COMMISSIONER'S DECISION

Amendments to drawings and claims to define the interaction of the step and riser elements of the access device were accepted. Rejection modified.

This decision deals with Applicant's request that the Commissioner of Patents review the Examiner's Final Action on application 298,391 (Class 105-228). The application was filed March 7, 1978, and is entitled MULTI-LEVEL ACCESS DEVICES. The inventor is Geoffrey R. Tregoning. The Examiner in charge issued a Final Action on May 8, 1981, refusing the application.

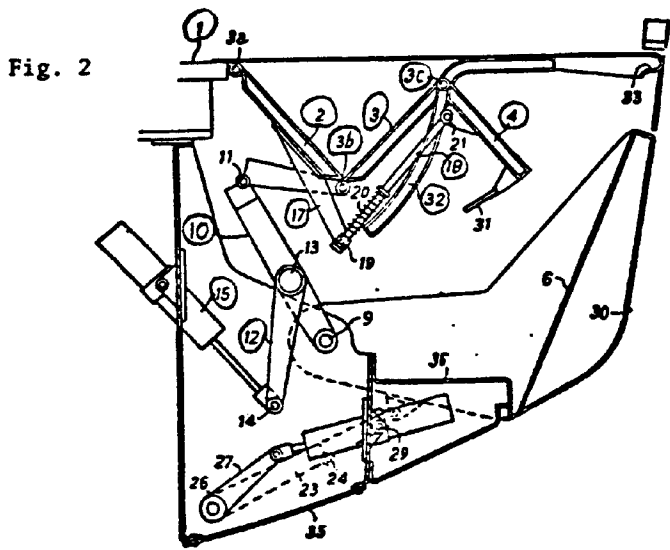
The application relates to an access device, formed of three interconnected parts, for use on a railway passenger car. Figure 2, reproduced below, illustrates the arrangement. A first part 1 has a hinge at one side which is attached to one side of second part 2. At its opposite edge part 2 is hinged to part 3. The opposite edge of part 3 is hinged at 3c to part 4. Guide means 32 are provided for guiding part 3 between a top position in which the three parts form a platform, to a lower position in which parts 3 and 2 form respectively a step and a rise. The guide means supports part 3 at the lower position. An over-center two-piece strut means 10 supports and actuates parts 2 and 3 at their hinge point 3b. A pivoted pneumatic cylinder 15 actuates the strut means using a connecting arm 12. Part 2 has an arm 17 extending therefrom which is connected to linkage 18 to move part 4 between the two positions.

An examination of the drawings, shows that if parts 4, 17, 18, 19 and 20 are omitted, then the third part 3 and second part 2 would not move in to place in an orderly manner such that part 3 will be a step and part 2 will be a riser.

The bracing action of elements 17, 18, 19 and 20 is required to control the movement of hinged elements 2, 3 and 4 in that element 10 will be able to raise or lower the said step elements 2, 3 and 4.

This is not correct. The strut 10 will move the hinged elements 2 and 3 to form a riser and step respectively without the presence of elements 4 and elements 17, 18, 19 and 20. The action of these latter elements is described at page 6 lines 14 to 20 and page 7 lines 13 to 23 of the specification. Applicants have reviewed this point on a working model, and confirm that the elements merely control the angle of the part 4 relative to parts 2 and 3 so that it also forms a riser.

In deployment of parts 2, 3 and 4 to form a step the hinge 3b is pulled, in the plane of the drawings, downwards and leftwards. Clearly, as the drawings show, hinge 3b swings about an arc centred on 3a having a radius determined by the length of part 2. To form a tread, part 3 must be substantially horizontal so that the lower end point of guide means 32 is critical since it supports 3c in the deployed condition. To form a riser part 4 would adopt the correct position if merely left to hang freely under the influence of gravity. The function of elements 17, 18, 19 and 20 is to produce a pronounced early "kick up" of the leading edge of part 14 to permit its engagement with the hooked sections 33 (Figure 2). Thus they have no substantive effect on the operation of the basic invention.

During review of the application and Applicant's arguments it became apparent that the model that Applicant referred to was different in some aspects than the arrangement of the access device shown in figure 3. We contacted the Agent who informed us that in the model, the guide means was closed at its lower end to retain the hinge means 3c connected to the step part 3. During

the discussion it was appreciated that in figure 3 of the drawings, which shows the access device in its step/riser mode, the drawing contained no end closing depiction for guide means 32. In figure 2 however, such a closure was shown, and support for the closure was found to be present in the disclosure.

By amendments dated March 4, 1983 and March 15, 1983, Applicant submitted respectively, drawing corrections to figures 1 and 3, and an amended claim 1 which reads:

We are satisfied that the above amendments to the drawings and to the claims are acceptable in view of the disclosure in the application.
